Stantec Consulting Services, Inc.
5 Burlington Woods Drive
Burlington, MA 01803

August 27, 2020

**Subject: Traffic Consulting Peer Review –
Proposed Gas Station/Convenience Store, Newbury, MA**

Peer Reviewer – Site Trip Distribution Estimates

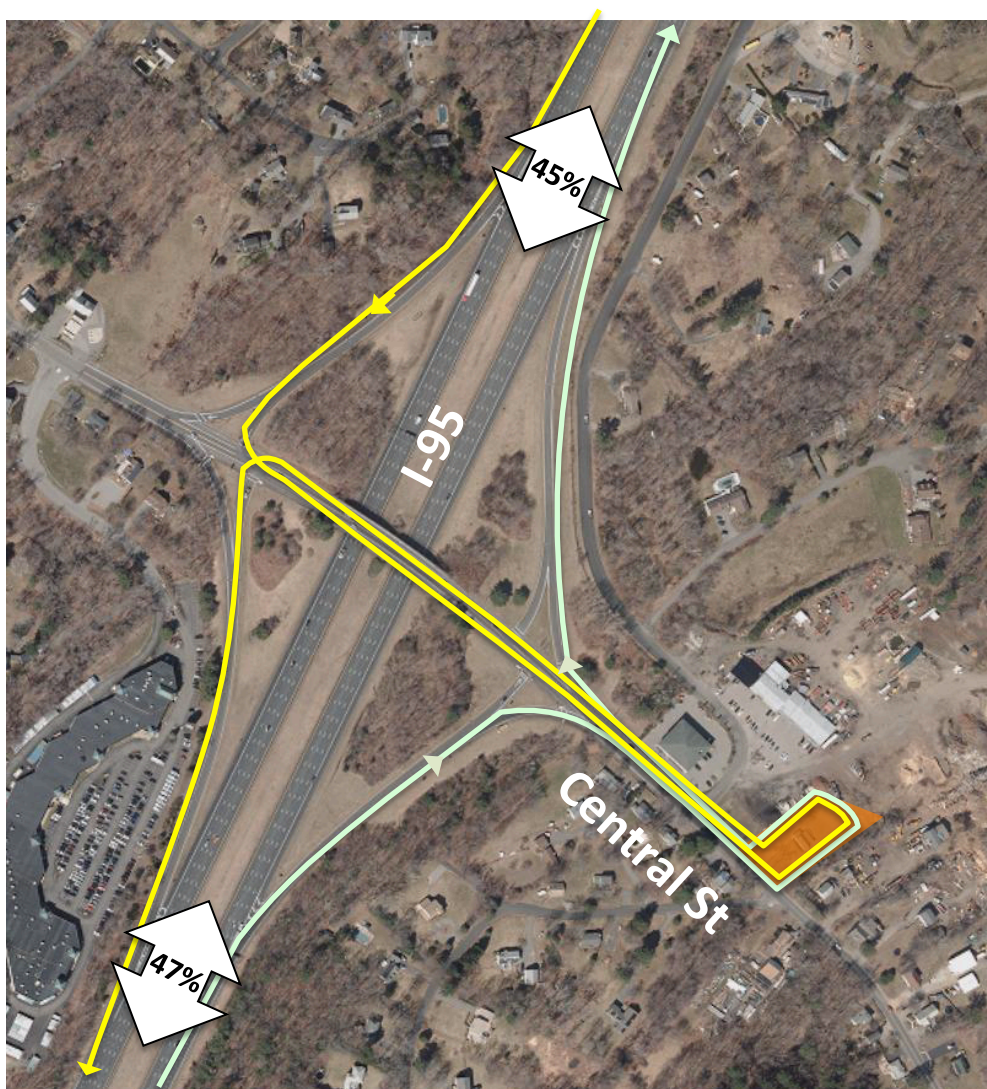
The Traffic Assessment assumes 60% of site-generated traffic will come directly from Central Street—30% east of the site and 30% west of the site, and 'at least' 40% from I-95. However, we anticipate a much stronger I-95 trip generation orientation, as I-95 carries are more than 10 times as many vehicles as Central Street. Also, there is likely to be new advertising on existing I-95 blue service signage (see right) prior to and at the Central Street exits from both directions. These signs already exist and have the capacity to accommodate

Therefore, in the context of MassDOT's available 2019 counts, we estimate approximately 8% of site-generated traffic will come from existing Central Street traffic – 4% to and from the east and 4% to and from the west, while 92% -- 47% to and from the south and 45% to and from the north - - will come from I-95.

While not 'new' trips in the sense that they come from separate origins and destinations, these 'diverted linked' pass-by trips will be entirely 'new' to the short Central Street link between the ramps and the site. An attachment to this letter illustrates the difference between the 'diverted-linked' pass-by trips and Central Street pass-by trips for accessing this particular site. We agree with the Traffic Assessment that this site will generate few trips that are 'new' to I-95 and Central Street.

'Diverted Linked' Pass-by Trips
(possibly 92% of all site trips w/47%
to and from the south and 45% to
and from the north)

Direct or 'Primary' Pass-by Trips
(possibly 8% of all site trips w/4% to and
from the east and 4% to and from the
west)

Central St. Traffic Calming Visual Slow Point - Option A – Exclusive Left Lane

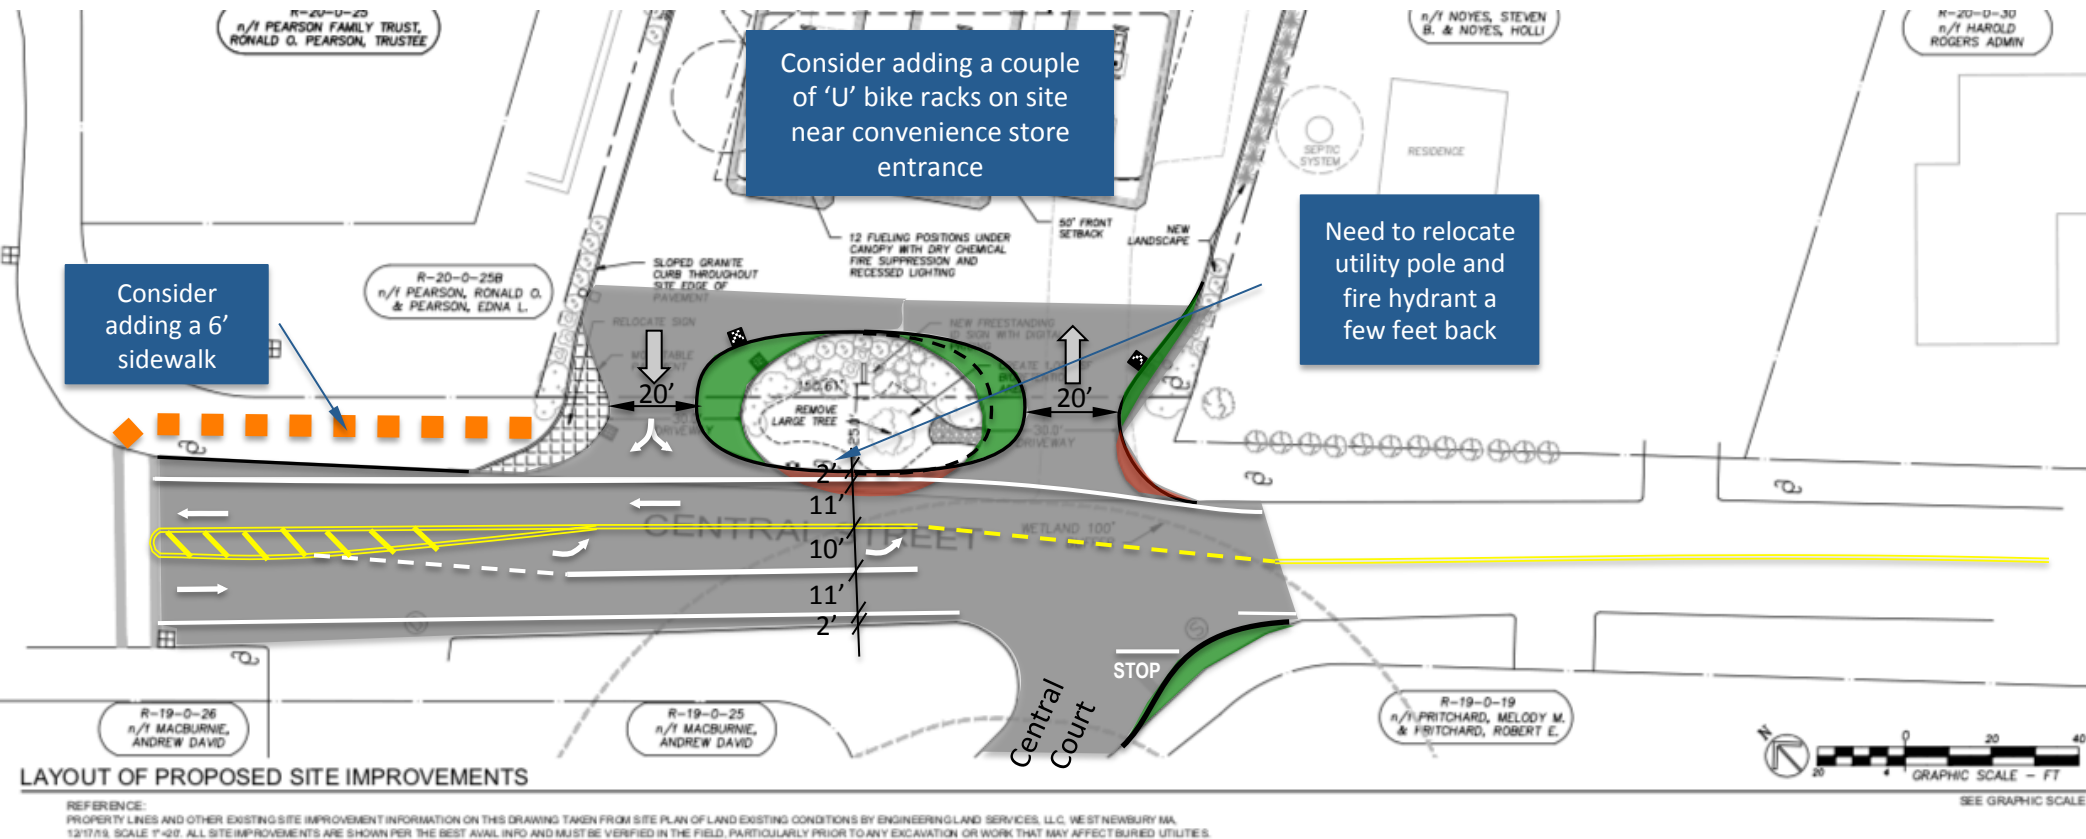
- **Consider providing some bypass opportunity for eastbound through traffic approaching the site from the I-95 interchange.** Our review of left lane warrants indicates that consideration of such a bypass is warranted based on the site's projected trip generation estimates as contained in the Traffic Assessment. Such delays will not be continuous, but will be occasional, causing some delays during peak arrival periods from 5-10 seconds. The need for this bypass or a left turn lane increases further if we assume I-95 will be the largest source of trips to and from the site. Three site access options, A, B and C d are attached to this letter. The goal of these options is to create a visual slow point on Central Street in the site vicinity. Each has pros and cons. These are identified on the sketches and all provide a visual slow point in front of the site. All are preferable to leaving the existing access condition as is.

Notes: best for left lane bypass, least bike friendly, may be less compatible with rural character

Central St. Traffic Calming Visual Slow Point - Option B – Larger Centerline Offset

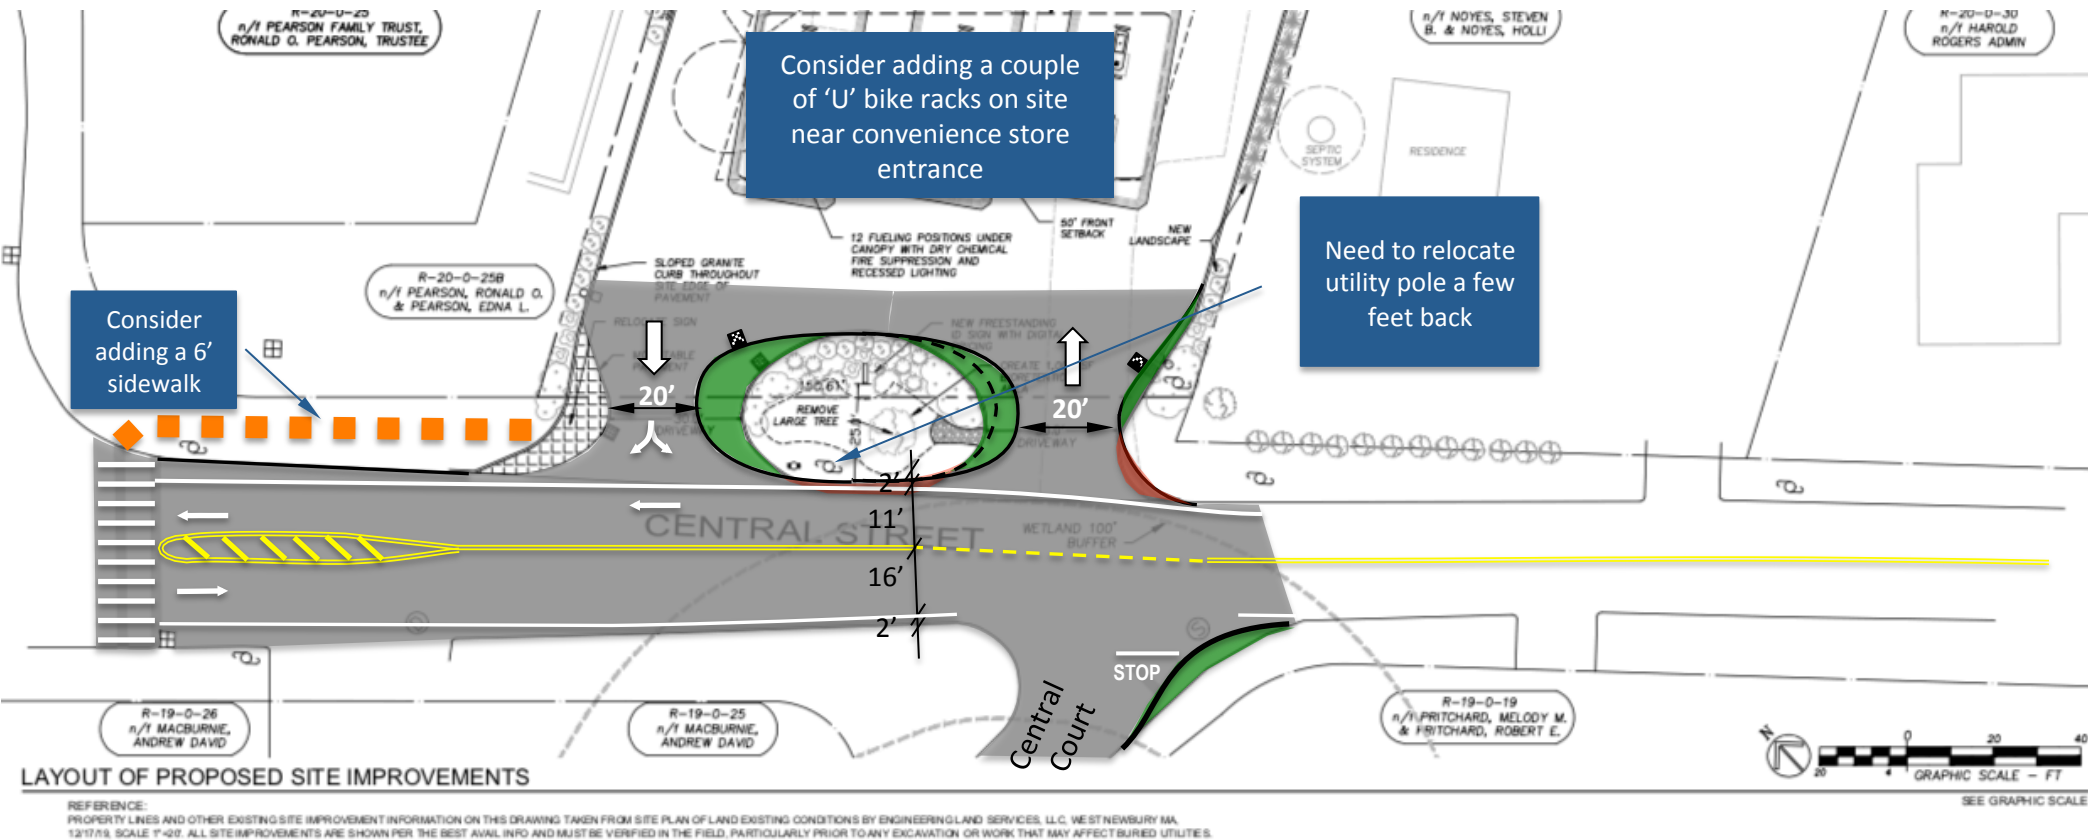
Notes: Better for left turn bypass potential, less bike friendly, consistent with rural character

Central St. Traffic Calming Visual Slow Point - Option C – Slight Centerline Offset

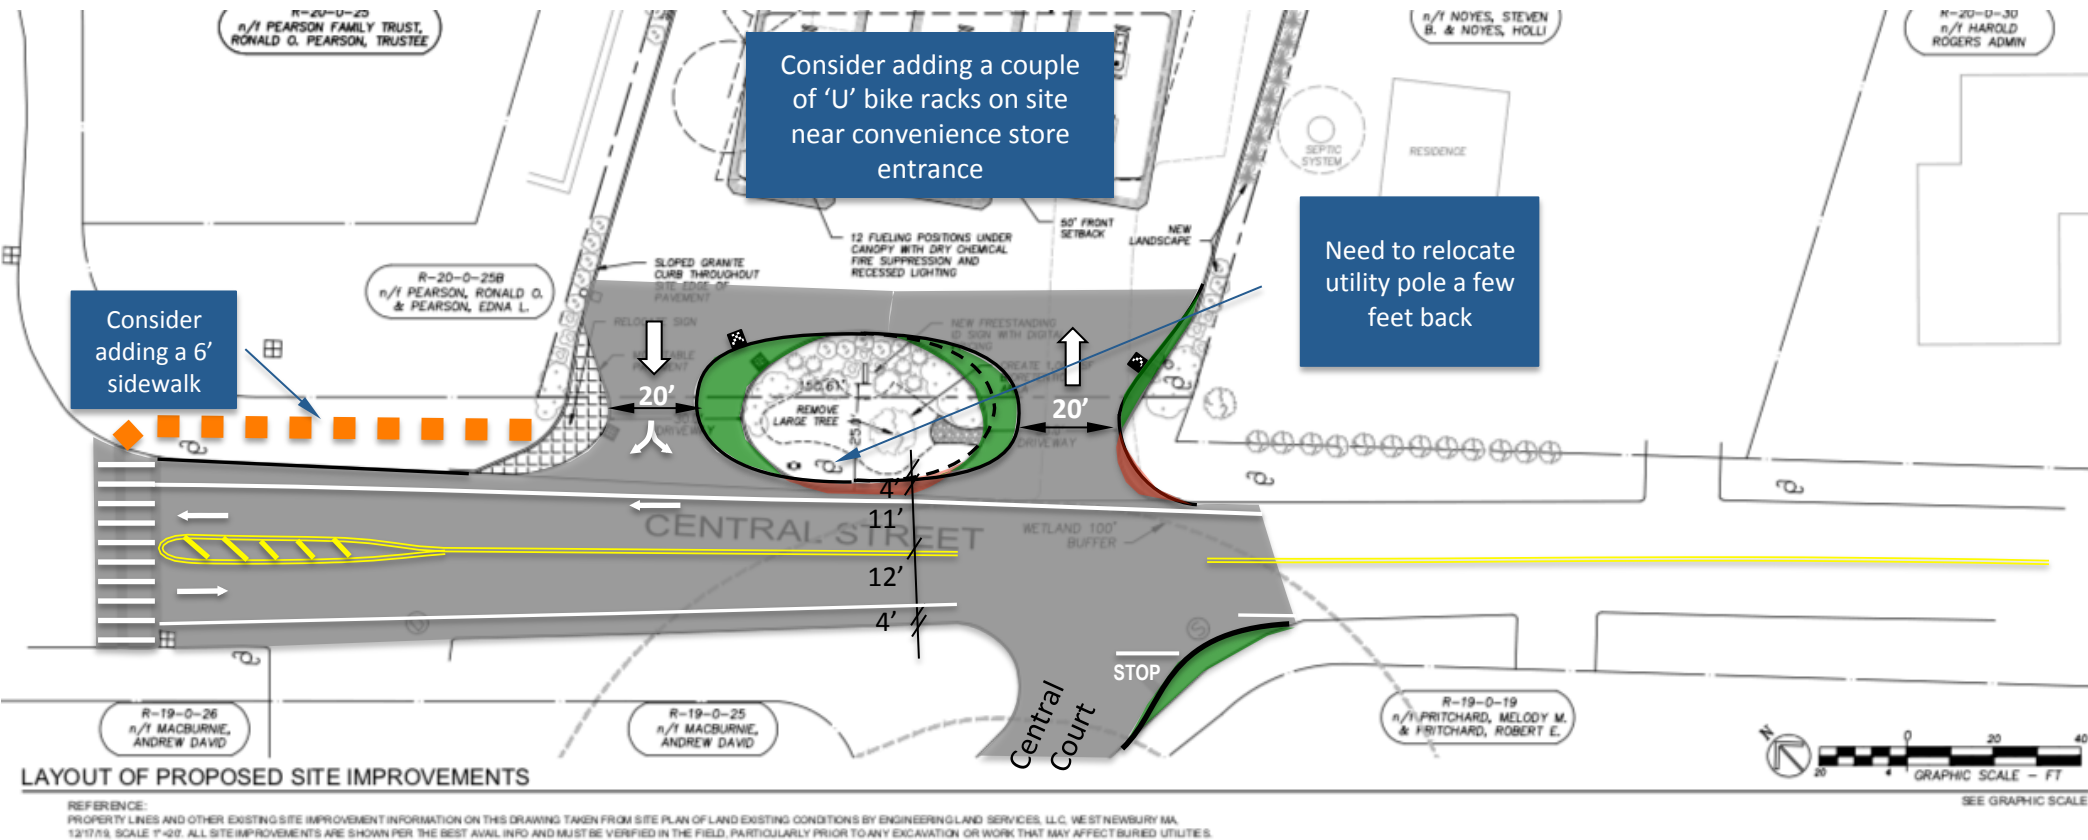
Notes: Occasional left turn bypass, most bike friendly, most compatible with rural character
